ECE/TRANS/WP.29/GRE/2008/53  
11 July 2008

Proposal for Supplement 3 to the 04 series of amendments to Regulation No. 48  
(Installation of lighting and light-signalling devices)

Submitted by the expert from France \*/

FIGURE (see paragraph 6. 5.)

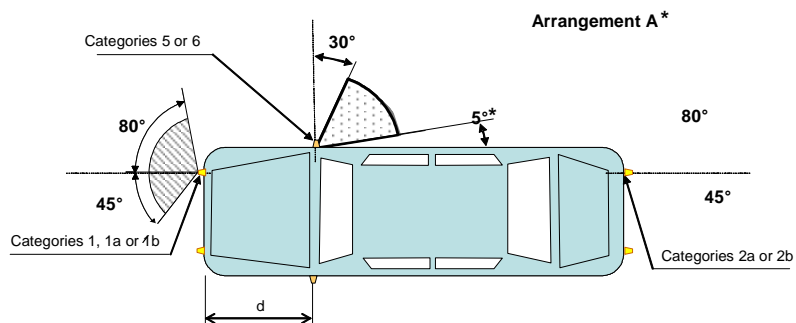
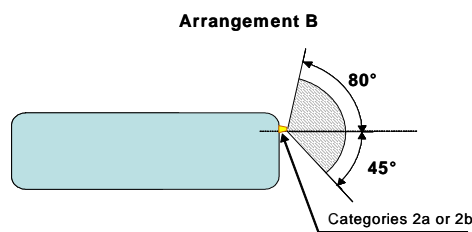
Paragraph 6.5.5.1., amend to read:

**For M1 and N1 category vehicles, the value of 45° inward for the direction indicator lamps of categories 1, 1a or 1b, may be reduced to 20° under the HH line of this lamp.**

(\*) The value of 5° given for dead angle of visibility to the rear of the side-direction indicator is an upper limit.  $d \leq 1.80$  m( for M<sub>1</sub> and N<sub>1</sub> category vehicles  $d \leq 2.50$  m)."

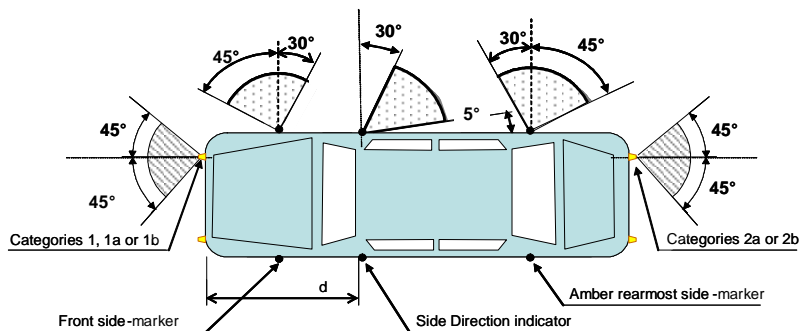
Paragraph 6.5.5.2., amend to read:

**The value of 45° inward for the direction indicator lamps of categories 1, 1a or 1b, may be reduced to 20° under the HH line of this lamp.**

(\*\*) The value of 5° given for dead angle of visibility to the rear of the side-direction indicator is an upper limit.  $d \leq 2.50$  m."
